UNICLIMA is the french association which represents the interests of Heating, Ventilation, Air conditioning and Refrigeration industries.

## 1. Unidirectional units-fans

## **2. SFPint : Comments about preliminary draft explanatory note**

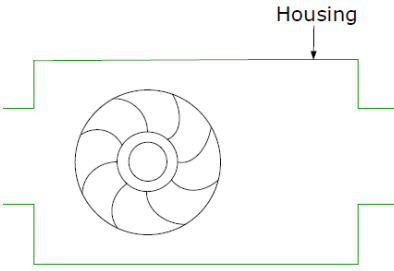
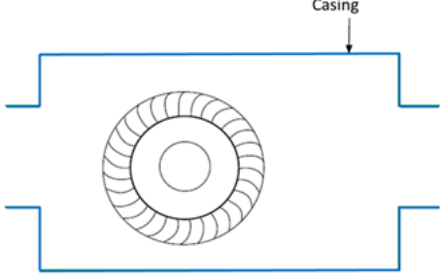
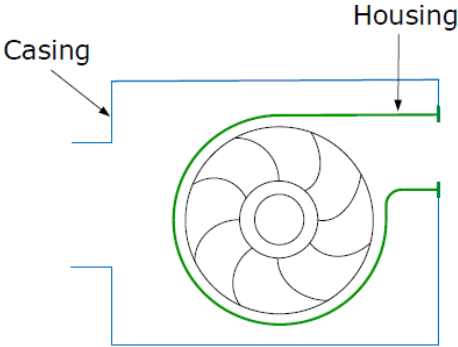
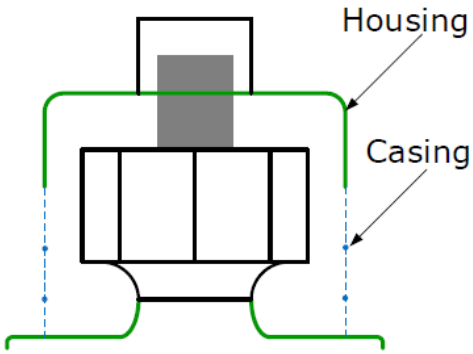
The systematic approach proposed in the document which considers only a first layer and a second layer (without any function consideration) is a nonsense.

Extract from discussion document	Comments
<p><a href="#"><u>Precision of the definition of housing</u></a></p>	<p>327 regulation says that an 'Housing' means a casing around the impeller which guides the gas stream towards, through and from the impeller ; what means very close to the impeller?</p> <p>Is the inlet and outlet structure of an axial fan as in duct fan considered as "housing" or "casing", it needs to be more precise.</p>  <p><b>(c) Vane-axial with inlet bell, inlet guide vane, outlet diffuser &amp; vane.</b></p>

<p><u>Figure 10 : « Fan with large housing »</u></p> 	<p>The fan has no housing but a casing. The green lines may be in blue</p> <p>For us in this case, this ventilation unit shall fall under Regulation 1253/2014 ( see figure below)</p> 
<p><u>Figure 12 : Ventilation unit including fan with scroll housing and casing</u></p> 	<p>Products of figure 10 and 12 have the same functionality from the end user point of view. They have to be in the scope of the same ErP regulations. With the first/second layer approach they would be considered differently, what is misleading.</p> <p><b>Both fans technologies (forward curved with scroll and backward curved with or without scroll) have to be dealt in the same way.</b></p>
<p><u>Figure 14 : « Ventilation unit with fan and grilles »</u></p>  <p><i>Figure 14 Ventilation unit with fan and grilles</i></p>	<ul style="list-style-type: none"> <li>○ The inlet cone is the only part of the fan housing. Any other green or blue parts have to be considered as casing</li> <li>○ <b>Products of fig 3, 4, 14, 16 have the same function and have to be treated in the same way.</b> This is not the case with the first/second layer approach</li> </ul>

**We ask for the removal of the first/second layer approach and to be consistent with R327 approach .**
